Illinois Department of Transportation

We are writing to inform you that the Illinois Department of Transportation (Department) has recently initiated preliminary engineering and environmental studies (Phase I) for the improvement of Illinois Route 53 at Old Hicks Road in the Village of Long Grove in Lake County. A location map is enclosed for your reference. This improvement is included in the Department's Fiscal Year 2012-2017 Proposed Highway Improvement Program contingent upon plan readiness, land acquisition, and funding availability through our future annual legislative appropriations. The proposed project is anticipated to consist of intersection improvements.

**Proposed Improvement: IL Rte 53 (FAU 1261)
 At Old Hicks Road
 Village of Long Grove
 Ela Township
 Lake County**

**Illinois Route 22 from Quentin Road to Illinois Route 83
Bicycle and Pedestrian Planning Information**

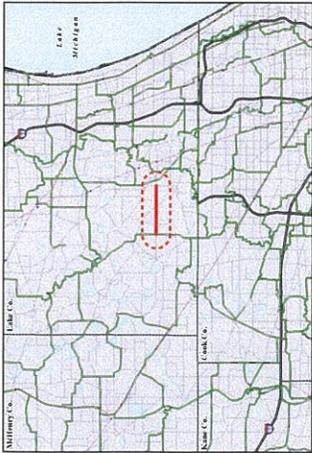
There was concern about the 20% match associated with this proposal and where those funds would come from implementation/completion of this project. The consensus of the Committee was to be aware of the match requirement to deal with the funding issue in the future.

Response: At the end of Phase I, a Letter of Intent will be sent the Village which will estimate the Village's cost participation and maintenance requirements.

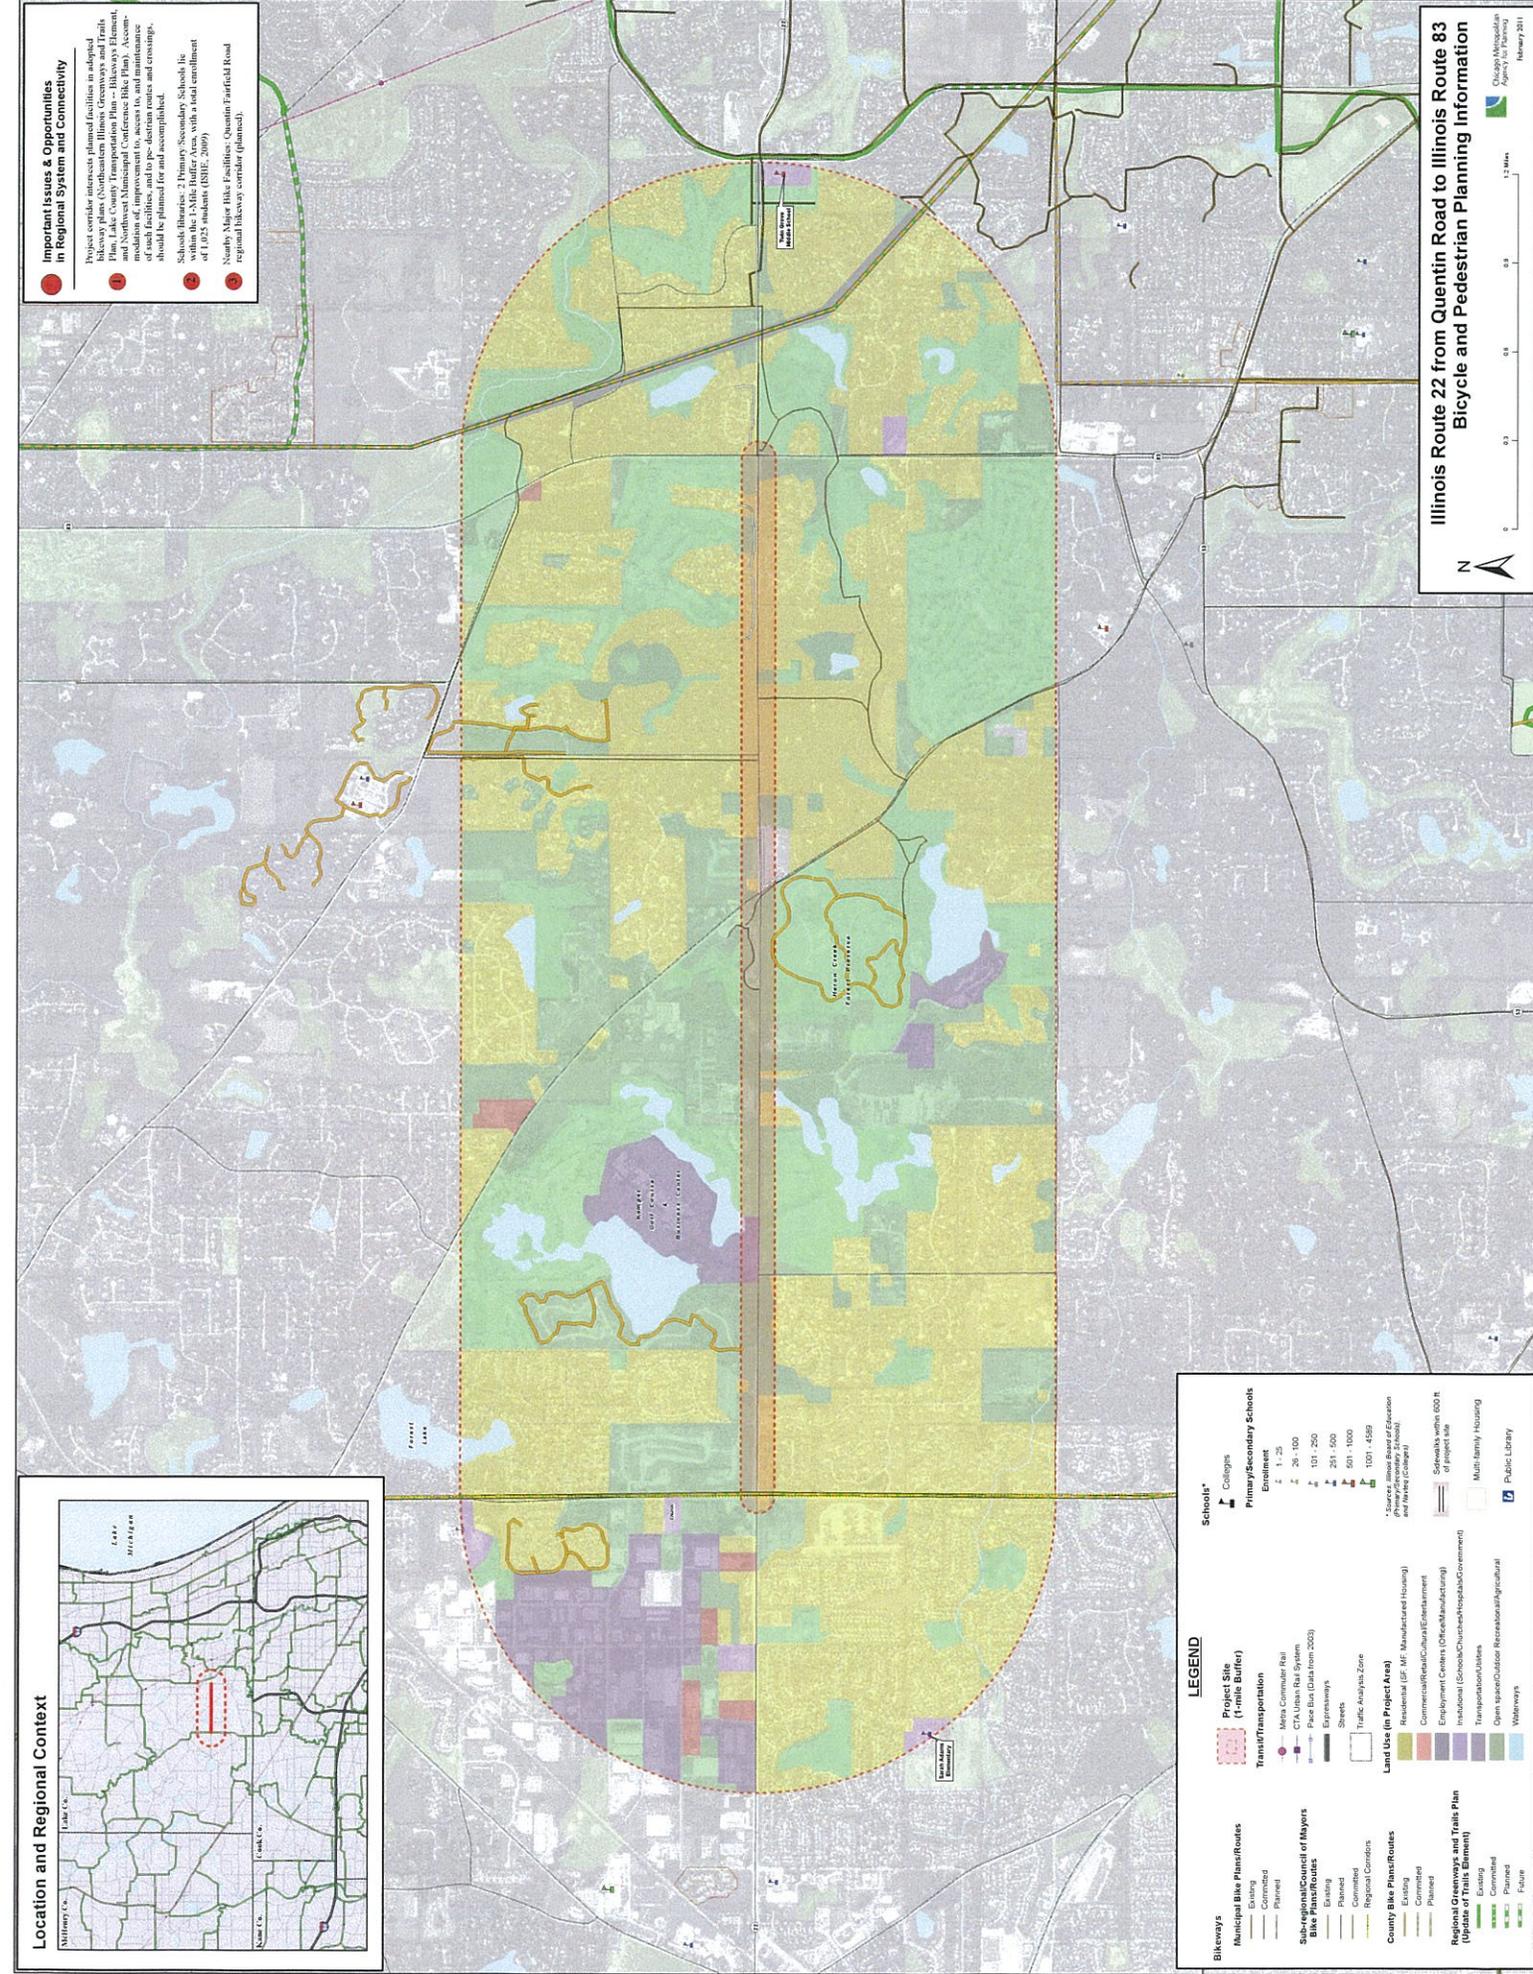
- **Sidewalks and Bikeways:** At a minimum, we recommend that IDOT construct sidewalks along Illinois Route 22 where they are currently missing (the majority of the project corridor – see separate map). These – and all other pedestrian facilities – within the project site should be compliant with the proposed Public Right-of-Way Accessibility Guidelines (PROWAG).¹ We further recommend that IDOT consider upgrading a sidewalk to bikeway standards (side path) to provide space for a bikeway, in keeping with the complete streets approach to roadway design.

Figure 1: IL-22and Quentin Road

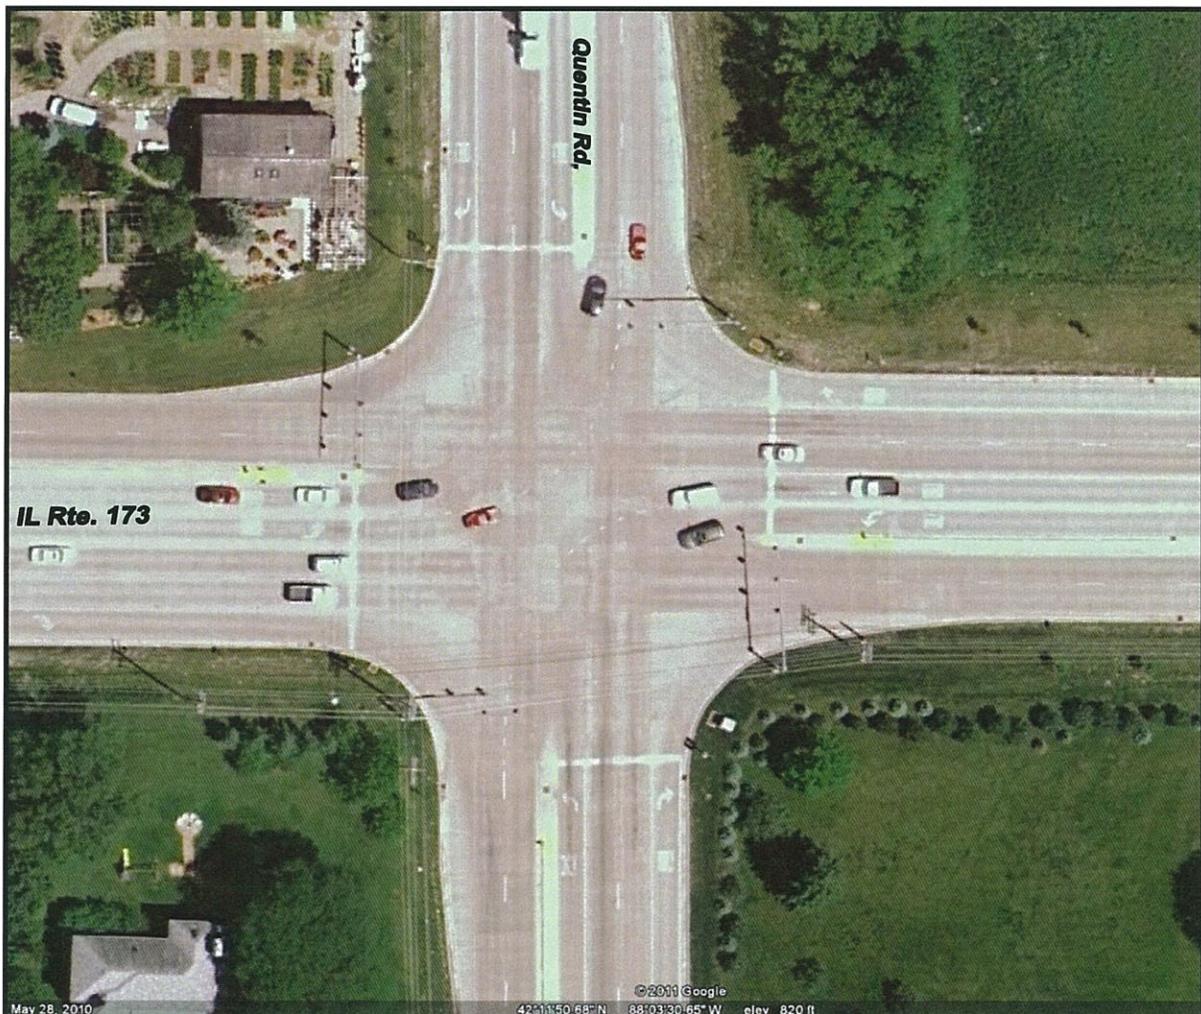
Current conditions at key intersections are shown below in **Figures 1-3**. No pedestrian and bicycle accommodation (pedestrian signals, marked crosswalks, etc.) exist at these intersections or along the

- **Intersection Design:** We strongly recommend that IDOT include geometric and traffic control device improvements to the three signalized intersections (Quentin Road, Old McHenry Road, Illinois Route 83) along the project corridor, in order to more fully and safely accommodate pedestrians and cyclists traveling along and across Illinois Route 22. Specifically, we make the following recommendations:

- **Pedestrian Crosswalks.** We recommend that pedestrian (countdown) signals be installed on at least two of the legs of the signalized intersections

Figure 4: Recommend Design for Right-turn Slip Lanes

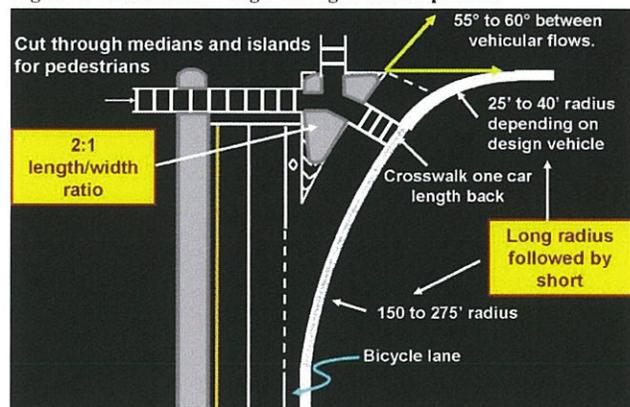
- **Tighter Intersection Design.** Given the high speeds and high ADTs, particular attention to the effect of pedestrian crossings on signal timing must be given. Reducing crossing distances, curb-to-curb, subject to MUTCD signal timing guidance, will reduce pedestrian clearance time in the intersection, thus will add flexibility to the allocation of green time at the congested intersections. Therefore, we recommend consideration of 10-11 foot travel lanes and properly designed pork-chop islands (see below) at the signalized intersections to narrow pedestrian crossing distances. This will not only improve signal timing flexibility but also improve pedestrian safety by reducing exposure to moving traffic.

- *Pork Chop Islands.* We recommend that IDOT study the feasibility of raised ‘pork chop’ islands at the signalized intersections. Providing “pork-chop” islands and turning roadways like those shown in **Figure 4** (above) can significantly reduce the amount of time required for pedestrian crossings, improving pedestrian safety and adding flexibility to signal operations. These pork-chop islands are strongly recommended for intersections like these (4+ lanes, high speeds, and high ADT). Pedestrian crossing signals should be utilized at the pork-chop islands. Should ‘pork chop’ islands prove not to be feasible, then we would recommend that curb radii be tightened in order to shorten pedestrian crossing distances and lower the speed of turning vehicles.
